**State of Alaska
Department of Fish and Game
Sportfish Division**

**Nomination Form
Anadromous Waters Catalog**

Anadromous Waters Catalog Number of Water Body 247-41-10200-2081-3035 (-0030); 247-41-10200-2081-3057-4011 (-0020)

Nomination # <u>25-547</u>	 Fisheries Scientist	<u>5/19/2025</u> Date
Revision Year: <u>2026</u>	 Habitat Operations Manager	<u>05/19/2025</u> Date
Revision to: <input checked="" type="checkbox"/> Atlas <input checked="" type="checkbox"/> Catalog	 AWC Project Biologist	<u>22 April 2025</u> Date
Revision Code: <u>C-9, C-1a, C-8, C-1, D-1</u>	 GIS Analyst	<u>7/11/2025</u> Date

Map #3

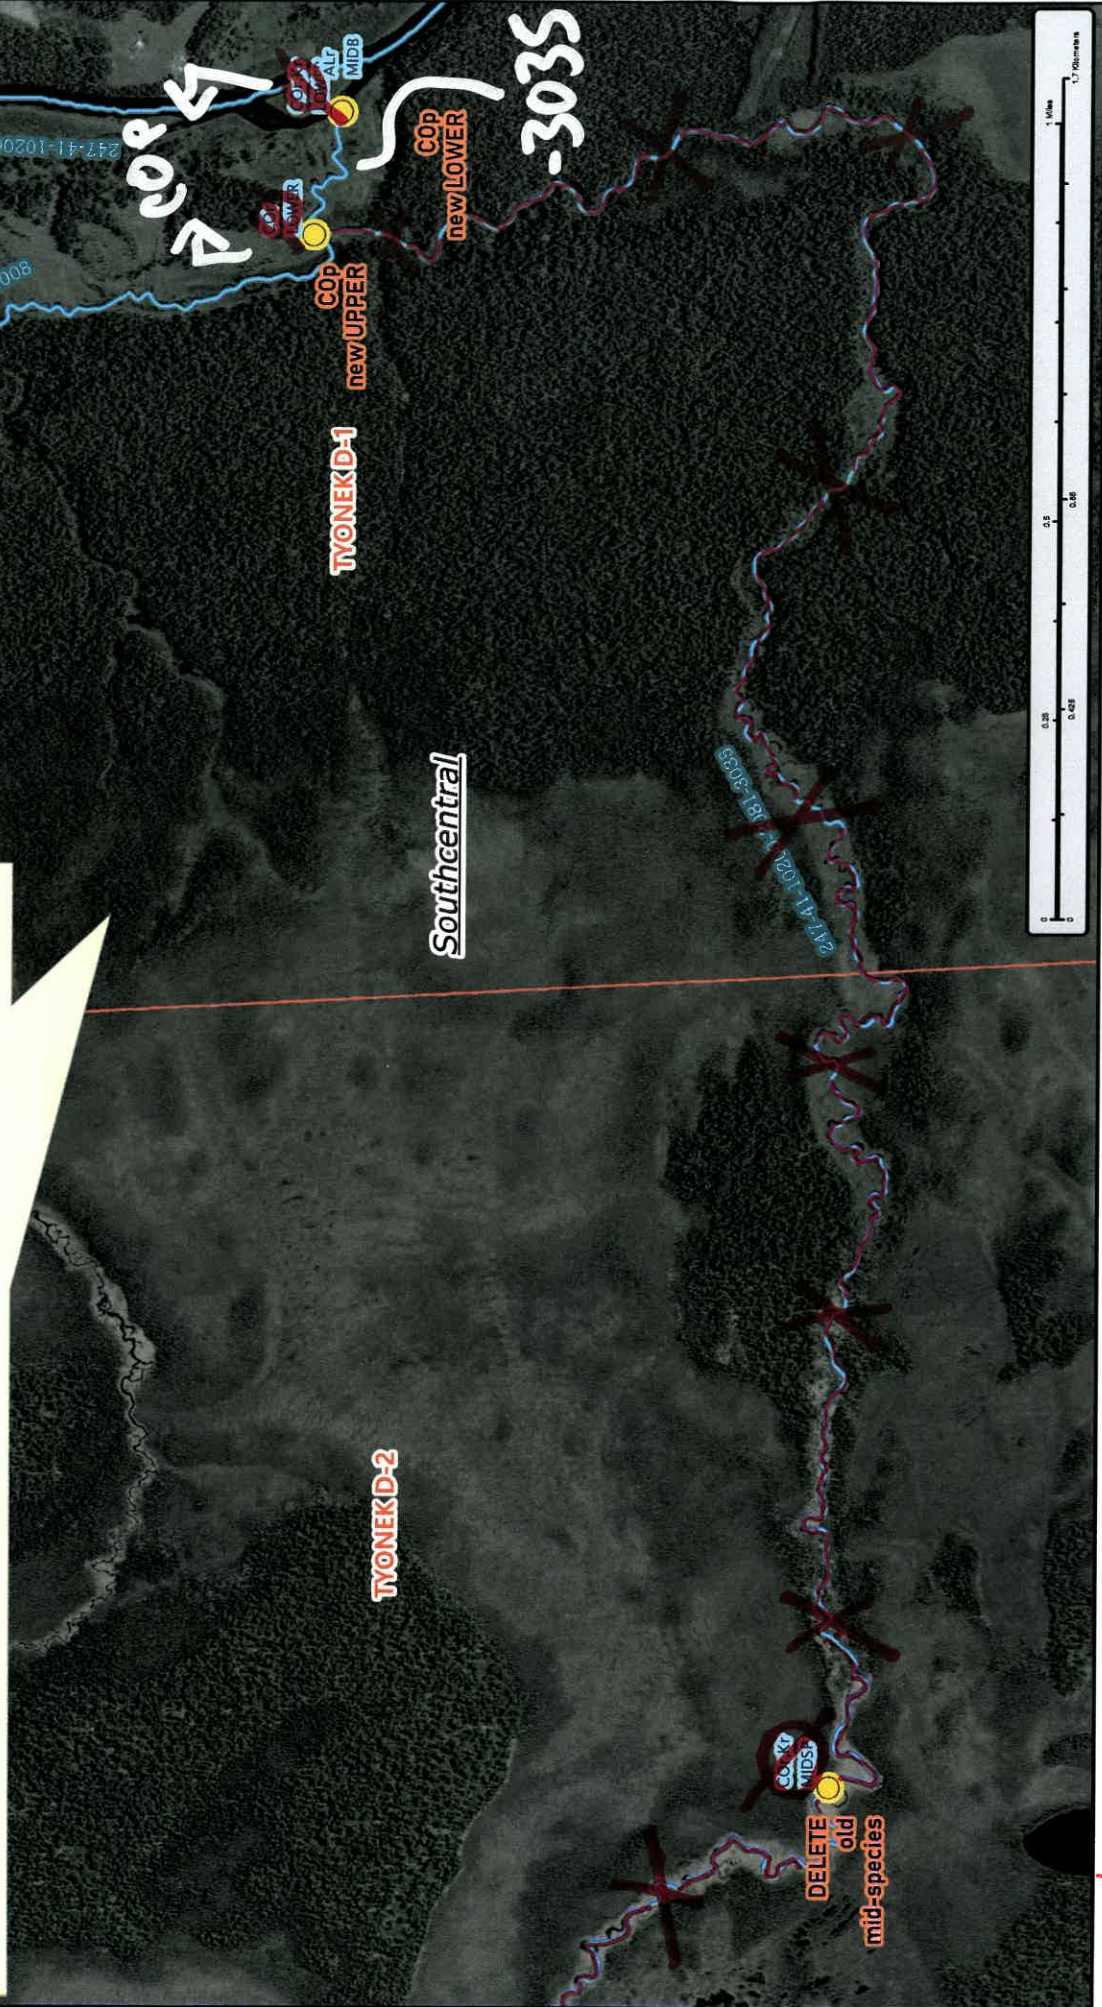
- UPDATE/CORRECT hydrography of upper reach of existing AWC Stream #247-41-10200-2081-3035, separating it to create a new AWC Stream that will be renumbered.

- RENUMBER above described new stream line from existing AWC Stream #247-41-10200-2081-3035 to new AWC Stream #247-41-10200-2081-3057-4011.
 - ADD COHO salmon PRESENT to new AWC Stream #247-41-10200-2081-3057-4011 as-per standard life-phase scheme.

- RENUMBER existing AWC Lake #247-41-10200-2081-3035-0030 to AWC Lake #247-41-10200-2081-3057-4011-0020.
 - SHORTEN remaining upper extent of existing AWC Stream #247-41-10200-2081-3035 down to the confluence with tributary ending -4008.

- CHANGE species in AWC Stream #247-41-10200-2081-3035 from COHO salmon REARING to COHO salmon PRESENT only.
- Please update using most recent .GDB with line, point, lake, polygon and barrier features located in O:\DS\FIR5\AWC\IDraft\2026\GIS\Data\AWC2026_WrkingV1_7April2025.gdb

Map #4

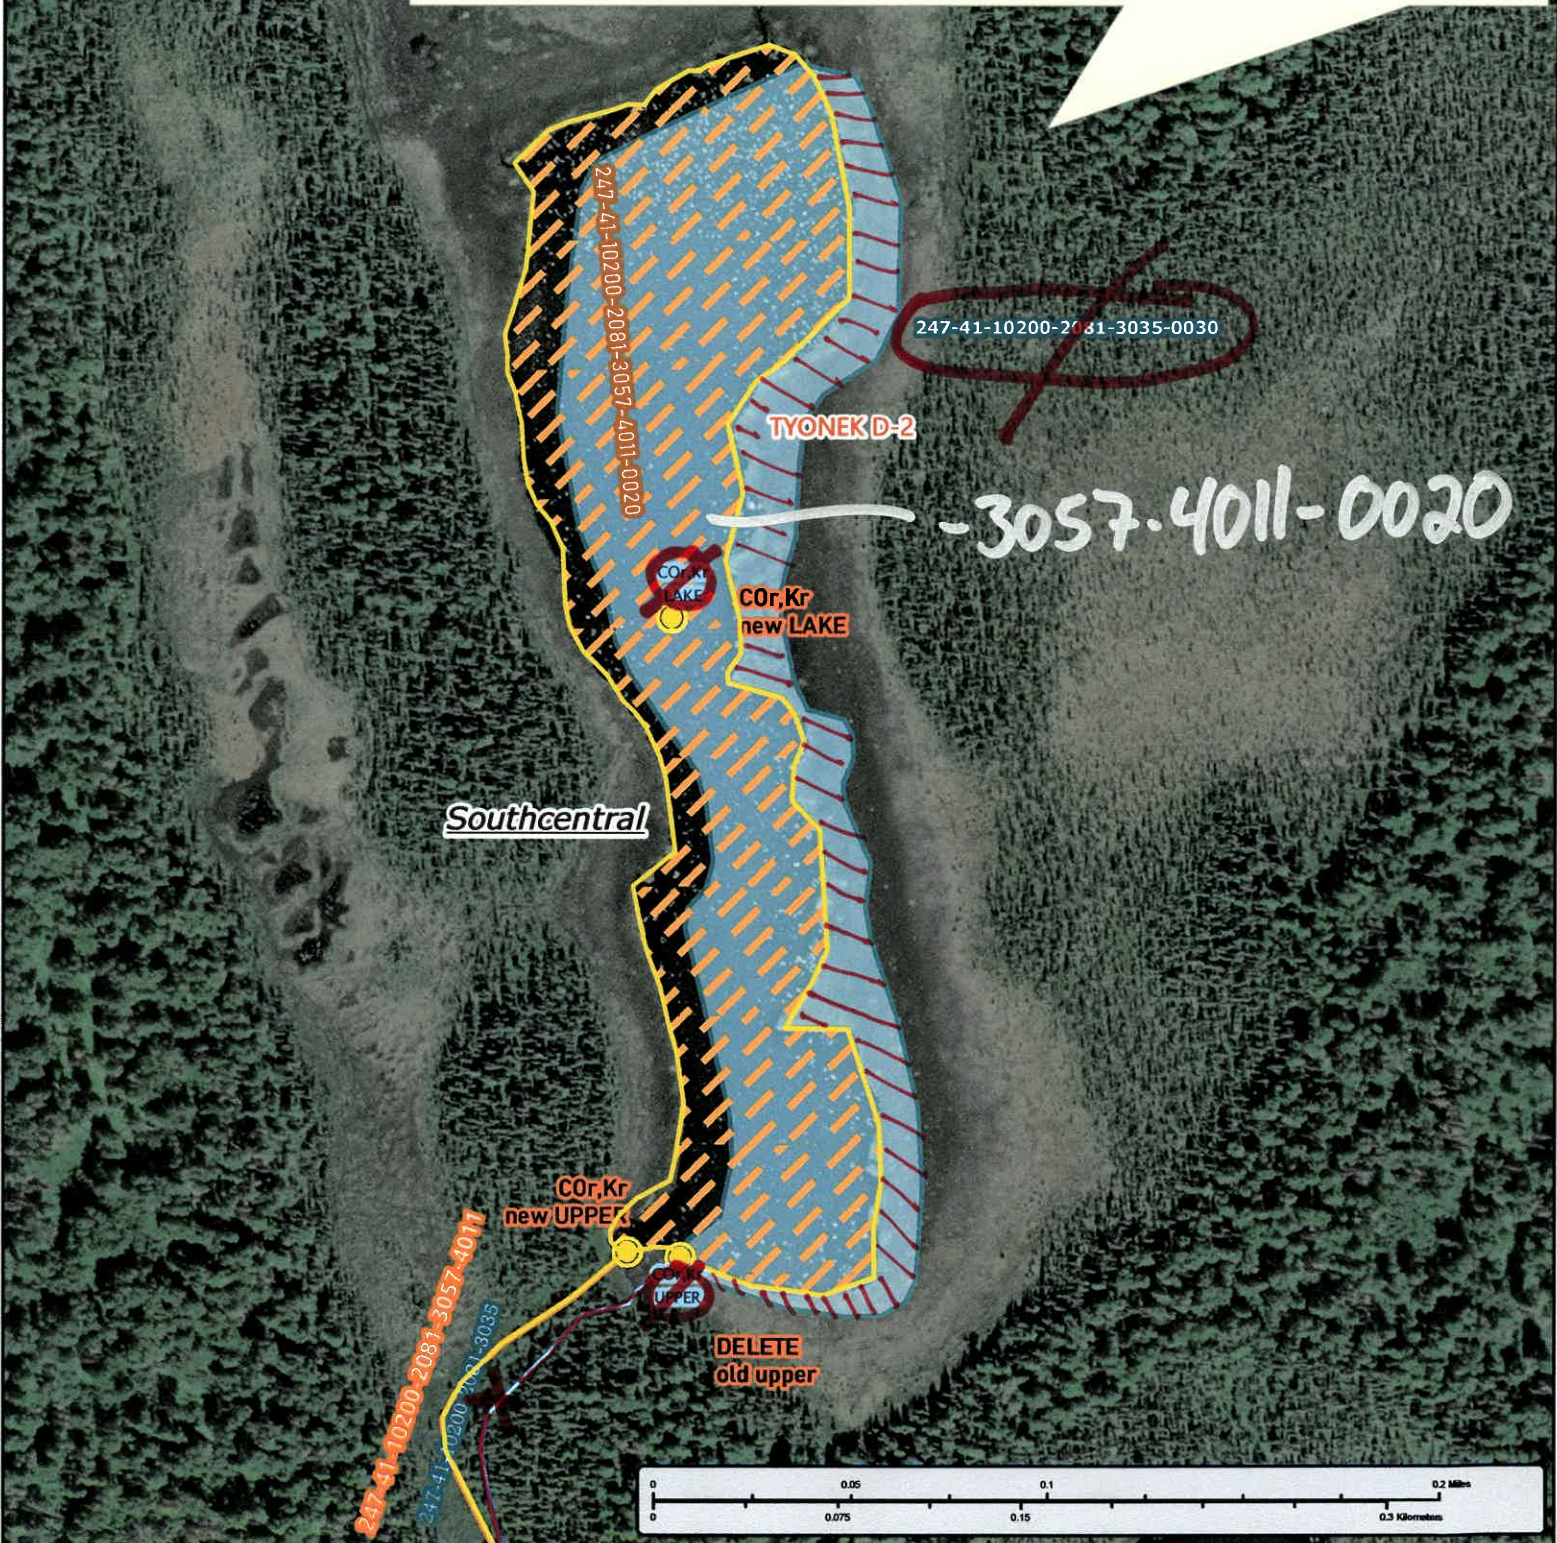
~UPDATE/CORRECT hydrography of upper reach of existing AWC Stream #247-41-10200-2081-3035, seperating it to create a new AWC Stream that will be renumbered.

~RENUMBER above described new stream line from existing AWC Stream #247-41-10200-2081-3035 to new AWC Stream #247-41-10200-2081-3057-4011.

~ADD COHO salmon PRESENT to new AWC Stream #247-41-10200-2081-3057-4011 as-per standard life-phase scheme.

~RENUMBER existing AWC Lake #247-41-10200-2081-3035-0030 to AWC Lake ##247-41-10200-2081-3057-4011-0020.

~SHORTEN remaining upper extent of existing AWC Stream #247-41-10200-2081-3035 down to the confluence with tributary ending -4008.

~CHANGE species in AWC Stream ##247-41-10200-2081-3035 from COHO salmon REARING to COHO salmon PRESENT only.
